## ALASKA NATURAL GAS DEVELOPMENT AUTHORITY

**SUBJECT: ANGDA Proposed Alignment Changes to Existing Alignment  
Glennallen to Palmer Natural Gas Spur Line  
Application for Pipeline Right-of-Way submitted April 4, 2005**

**PROPOSED REALIGNMENTS  
GLENNALLEN TO PALMER GASLINE**

**PROPOSED REALIGNMENT  
GLENNALLEN TO PALMER GASLINE**

FIGURE 15

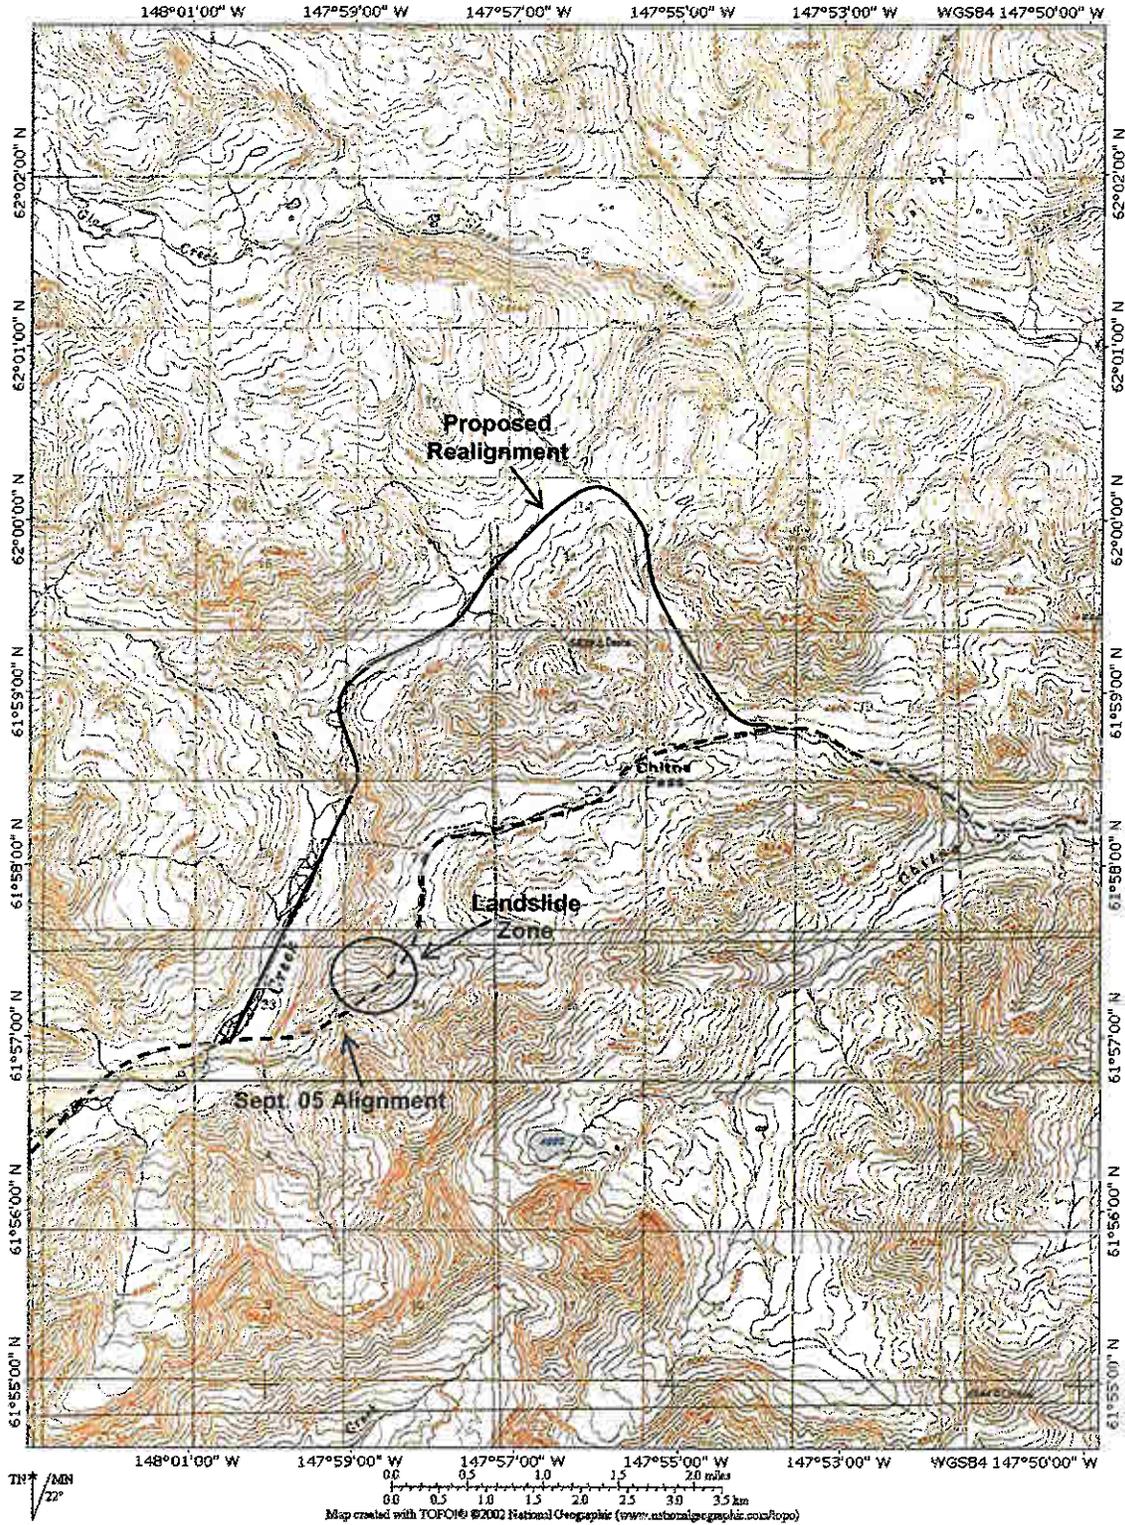
55	5.2.1 Chitna Pass Realignment	We recommend that the proposed northern realignment, as shown in Figure 15, be given further consideration.
55	5.2.2 Chickaloon River Crossing Realignment	We recommend shifting the alignment either up or downriver to a more advantageous crossing location.
58	5.2.3 Moose Creek Crossing Realignment	We recommend that consideration be given to moving the crossing either upstream as shown on Figure 18 or downstream to a location between the Glenn Highway and the Matanuska River.
61	5.4.1 Potential Material Sites	On the ground reconnaissance was not performed, but would be necessary to determine whether these sites contain sufficient quantities of suitable material to warrant further exploration.
67	5.4.1 Potential Material Sites	Future materials investigations should include a field reconnaissance study that takes into consideration estimated quantities and quality of material required, lands and ownership issues, and environmental concerns. A reconnaissance plan showing how the sites would be accessed should be prepared for review by ROW personnel.

88.1 – 92.4	Proposed Re-route  Chitna Pass	Go due north through a draw to the back side and turn westerly joining in to the headwaters of Boulder Creek. Keep generally to the right (west) side of the creek taking advantage of better alignment and broader banks working your way down to the broader flatter stream bed. Hold to the right side and join up with the Original alignment at about PLMP 92.4

FIGURE 16

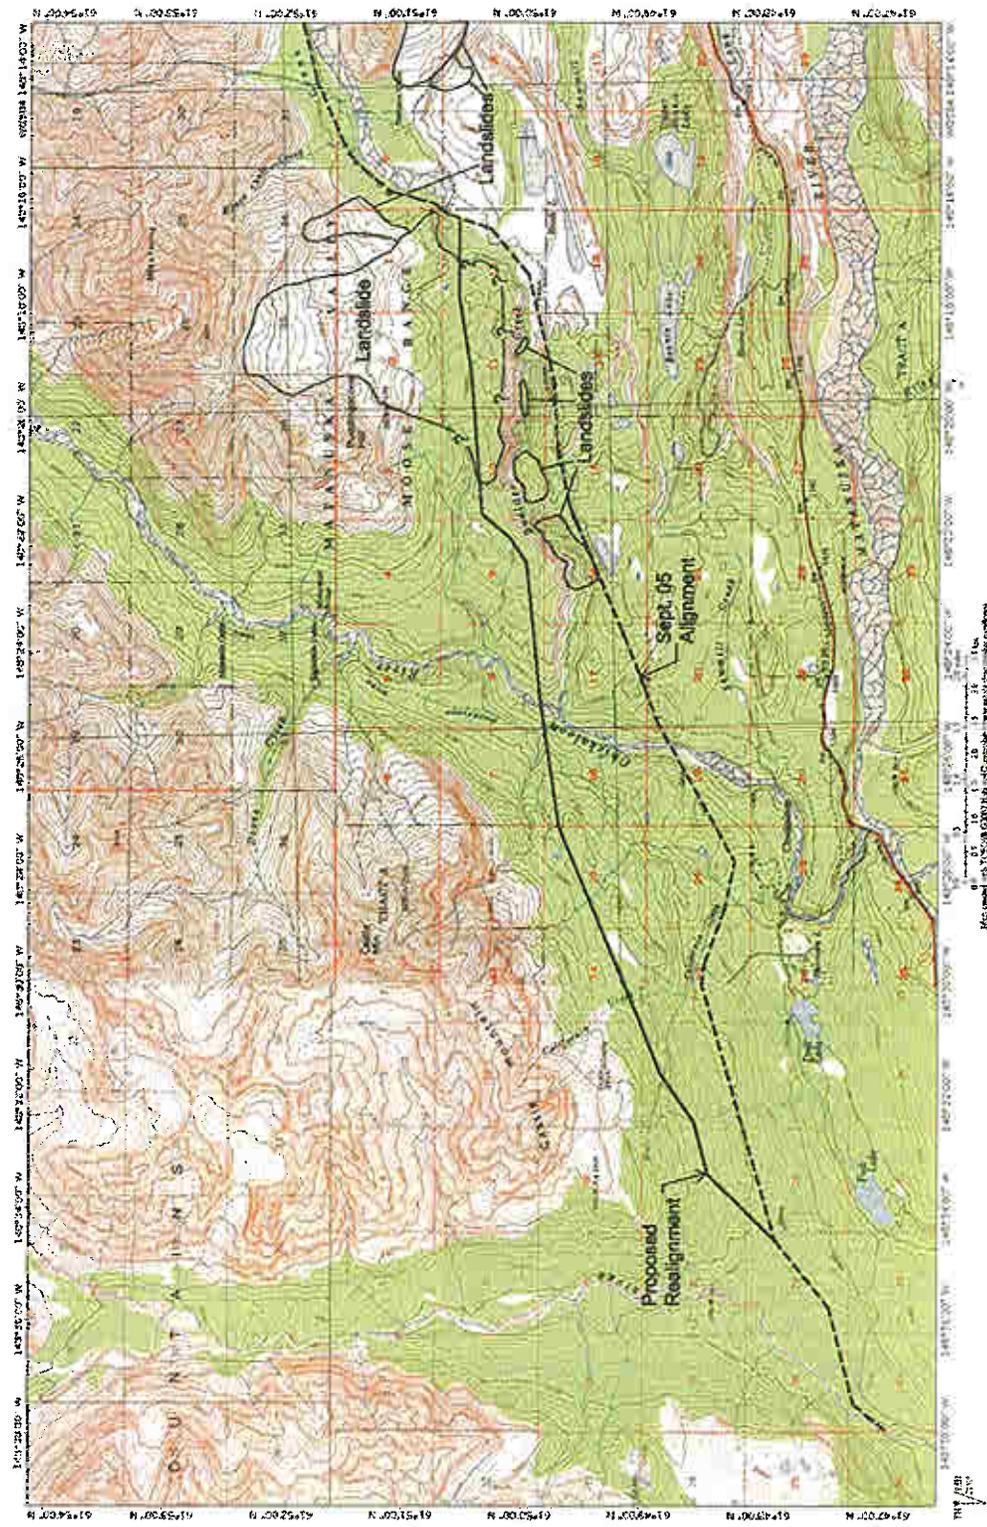
105 - 117	Proposed Re-Route Chickaloon	<p>It turned out that this proposed re-route is sweet. After crossing Boulder Creek at about PLMP 105 stay closer to the Right bank of the Boulder Creek Canyon thereby avoiding "wetlands" contained in a low drainage on the mountain side of the alignment.</p> <p>Follow the ridge fall line down to a location about 2 - 400 feet above the confluence of Chickaloon and Boulder Creeks. It may be possible to cross this stream using the open trench method. However, there also appears to be space enough to HDD because of the width of the stream bed at that location.</p> <p>Following the ridge fall line on the west side of the Creek up to about the 2200 foot level a "bench" is found. Staying to the left or southern side of the bench will keep you out of "wetland" pockets and take you up to a draw that can be used to lay the pipe through and lead you to a ridge like fall line down to about original PLMP 117.</p>

FIGURE 18

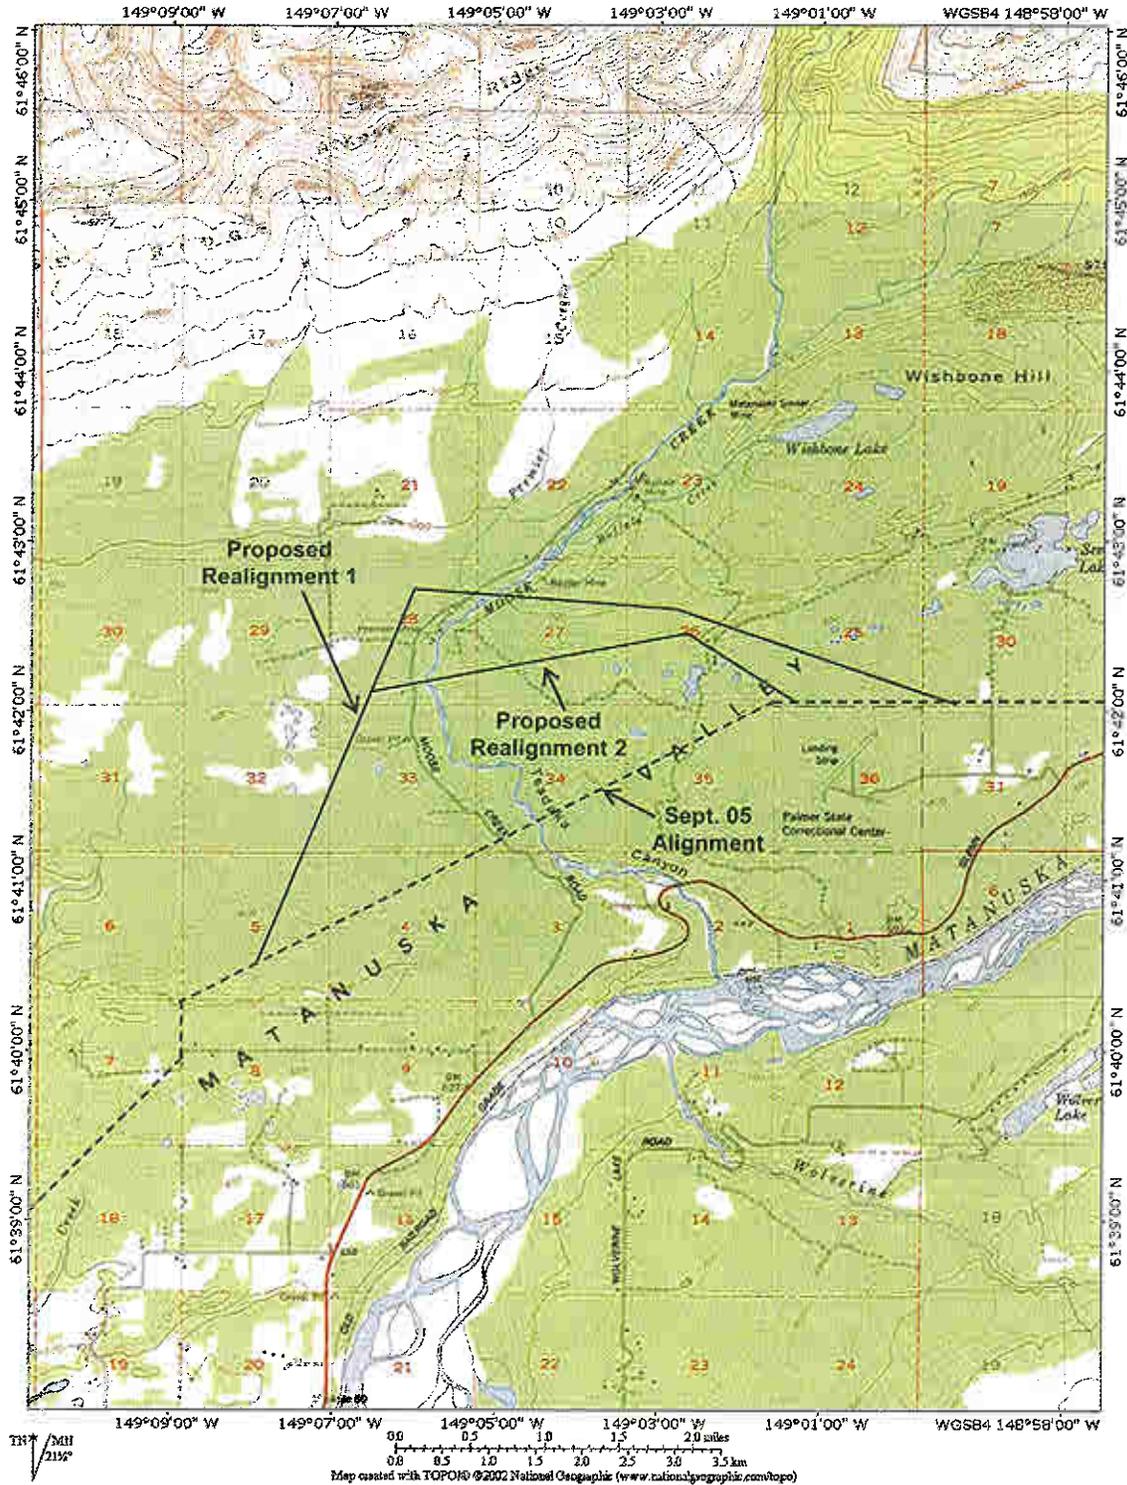
128 – 130	Check Status	Land Ownership
134.6	Proposed Re-Route  Moose Creek	It turns out that Moose Creek is a major Salmon spawning and rearing site. In any event, the original crossing may not be possible. If not, then upstream about 1-1.5 miles are HDD crossing opportunities. After crossing, angle SW to connect with the original alignment as quickly as possible and avoid homeowners and out buildings. There are several subdivisions in this area that will have to be carefully avoided or aligned to have minimum impact.
148	Terminus	There is a large gravel pad (guesstimate 30 acres plus) apparently owned by Peter Kewit Co (per Mike Bethe) that may be suitable for our propane, etc. facility. It is south of the Hospital, across the Parks Hwy, less than ½ a mile away and screened by trees. An Auto Race Track appears to be in the NE Corner of the pad.
